Important Changes in the range of Miniature Circular Connectors of 678 / 680 / 682 series

We want to continuously optimize our products and therefore we improved the male contact inserts of the 12 to 19-pole versions. This improvement affects all male versions of the series 678, 680 and 682 (field attachables, straight, angled and panel mount parts).

Representative example with 12 poles.
Also applies for 14, 16 and 19 poles.

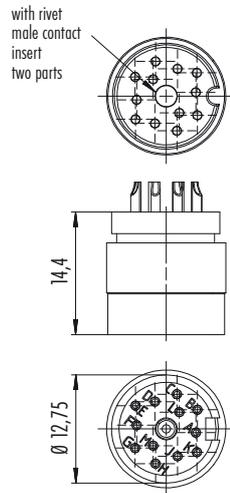
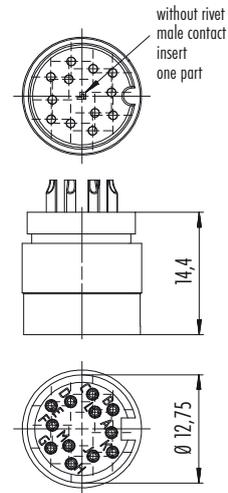
In the past the contact inserts have been two parts and in the future it will only be one part. There will be no dimensional change. Visually you will be able to see the difference as the rivet is missing. The contacts will be fixed mounted instead of floated-mounted.

Previous contact insert

New contact insert

All changes do not lead to application changes. The current versions can be replaced 1:1 with the new versions.
